Accessibility Survey

City of Downey Woodruff Avenue & Firestone Boulevard East

Date of Inspection 1/9/2017

Disability Access Consultants

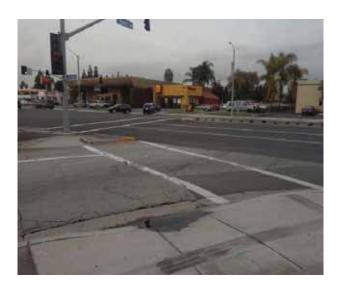
Crosswalk width is not compliant.

On-Site Finding 47.00 inches

Provide a compliant crosswalk for the intersection with recommended width.

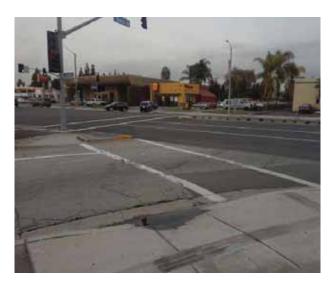
There are no detectable warnings provided for the crosswalk.

On-Site Finding Not Found

Provide compliant detectable warnings for the crosswalk.

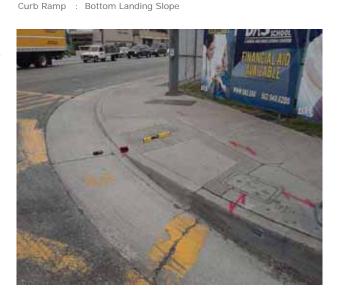
The bottom landing of the curb ramp is on the street, and the slope of the bottom landing is not compliant.

On-Site Finding 5.70 percent

Ensure the bottom landing slope is compliant and provides a smooth transition.

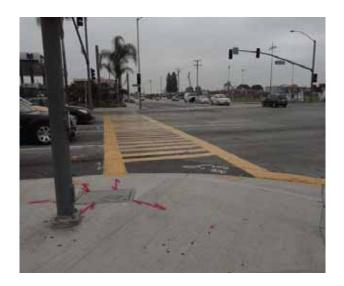
The clear ground space is not level.

On-Site Finding 7.00 percent

Provide compliant level clear ground space at the control.

Change In Level South Of Imperial Highway @ 33.916867834841, - 118.116540312767

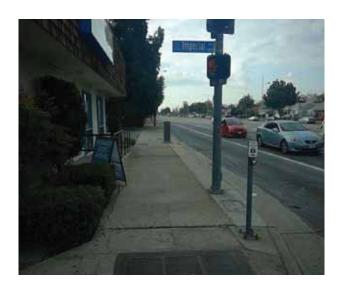
There is a change in elevation greater than recommended value.

On-Site Finding 0.75 inches

Ensure that the change in elevation is within the recommended value.

Change In Level West Of Buell Street @ 33.936303755294, -118.114855885506

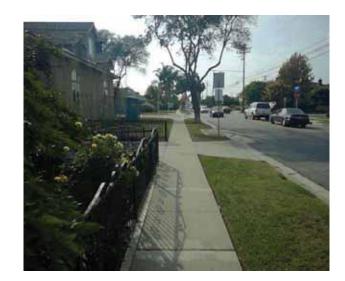
There is a change in elevation greater than recommended value.

On-Site Finding 0.75 inches

Ensure that the change in elevation is within the recommended value.

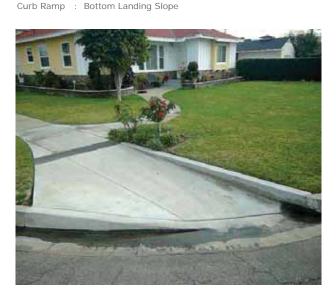
The bottom landing of the curb ramp is on the street, and the slope of the bottom landing is not compliant.

On-Site Finding 10.70 percent

Ensure the bottom landing slope is compliant and provides a smooth transition.

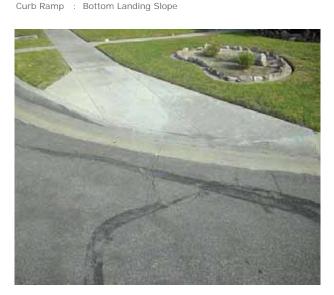
The bottom landing of the curb ramp is on the street, and the slope of the bottom landing is not compliant.

On-Site Finding 7.60 percent

Ensure the bottom landing slope is compliant and provides a smooth transition.

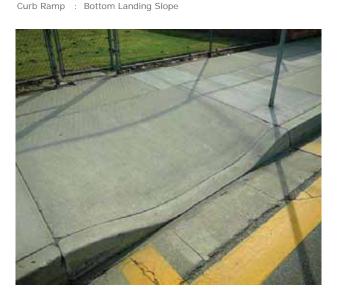
The bottom landing of the curb ramp is on the street, and the slope of the bottom landing is not compliant.

On-Site Finding 6.40 percent

Ensure the bottom landing slope is compliant and provides a smooth transition.

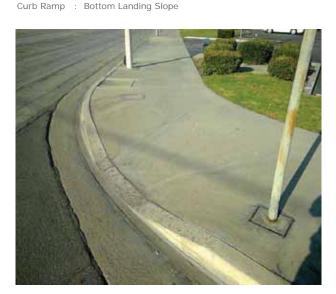
The bottom landing of the curb ramp is on the street, and the slope of the bottom landing is not compliant.

On-Site Finding 12.70 percent

Ensure the bottom landing slope is compliant and provides a smooth transition.

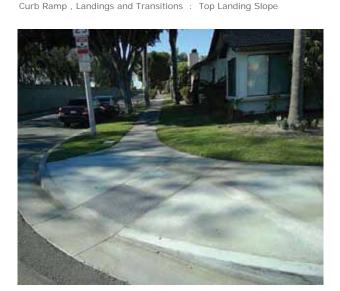
The slope at the top landing is greater than allowed.

On-Site Finding 2.40 percent

Provide a top landing surface that does not exceed the maximum slope and cross slope. Provide a sufficient maneuvering clearance that does not accumulate water.

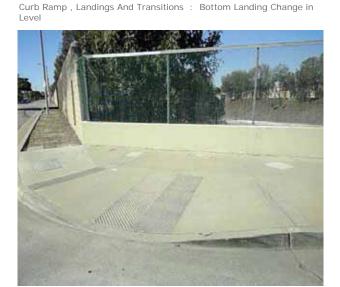
The transition from the bottom of the curb ramp to the walk, gutter, or street is abrupt.

On-Site Finding 0.62 inches

Patch the transition area at the bottom of the curb ramp so that the transition is flush and free of abrupt changes.

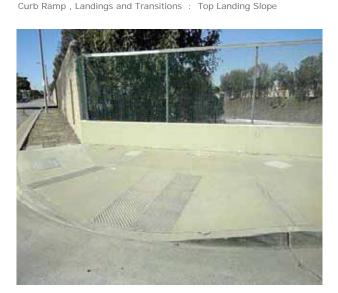
The slope at the top landing is greater than allowed.

On-Site Finding 2.50 percent

Provide a top landing surface that does not exceed the maximum slope and cross slope. Provide a sufficient maneuvering clearance that does not accumulate water.

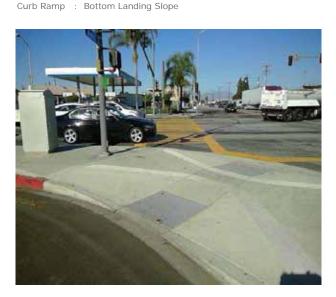
The bottom landing of the curb ramp is on the street, and the slope of the bottom landing is not compliant.

On-Site Finding 7.10 percent

Ensure the bottom landing slope is compliant and provides a smooth transition.

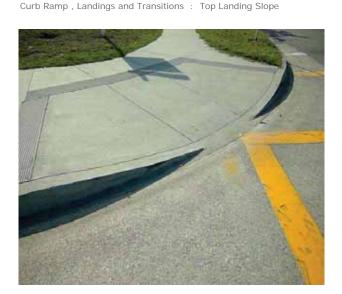
The slope at the top landing is greater than allowed.

On-Site Finding 4.30 percent

Provide a top landing surface that does not exceed the maximum slope and cross slope. Provide a sufficient maneuvering clearance that does not accumulate water.

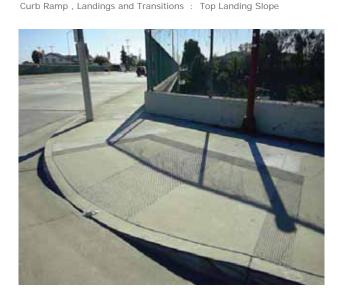
The slope at the top landing is greater than allowed.

On-Site Finding 3.00 percent

Provide a top landing surface that does not exceed the maximum slope and cross slope. Provide a sufficient maneuvering clearance that does not accumulate water.

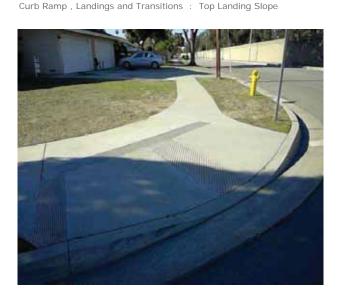
The slope at the top landing is greater than allowed.

On-Site Finding 4.90 percent

Provide a top landing surface that does not exceed the maximum slope and cross slope. Provide a sufficient maneuvering clearance that does not accumulate water.

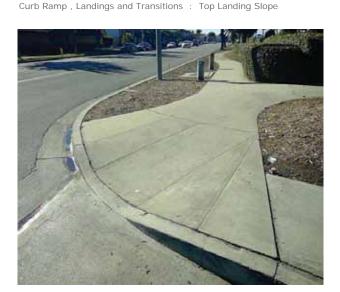
The slope at the top landing is greater than allowed.

On-Site Finding 6.80 percent

Provide a top landing surface that does not exceed the maximum slope and cross slope. Provide a sufficient maneuvering clearance that does not accumulate water.

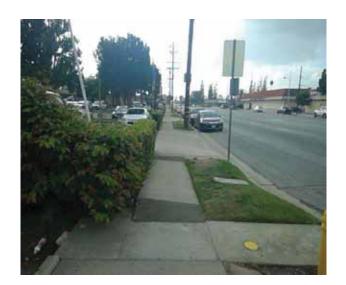
Sidewalk cross slope is not compliant.

On-Site Finding 9.00 percent for 17.00 feet

Repave the sidewalk surface with the recommended cross slope.

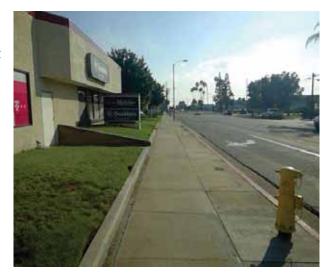
Sidewalk cross slope is not compliant.

On-Site Finding 3.20 percent for 148.00 feet

Repave the sidewalk surface with the recommended cross slope.

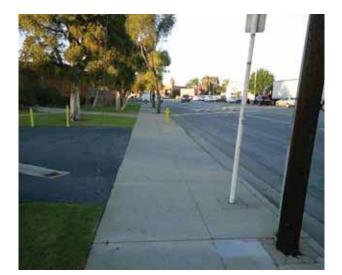
There are no detectable warnings where the pedestrian route crosses vehicular traffic.

On-Site Finding Not Found

Provide detectable warnings.

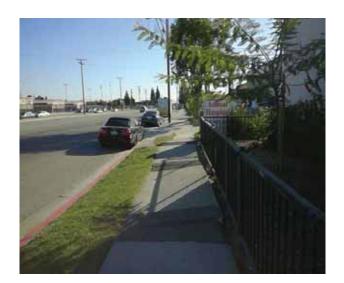
Sidewalk running slope is not compliant.

On-Site Finding 9.80 percent for 43.00 feet

Repave the sidewalk surface with the recommended running slope.
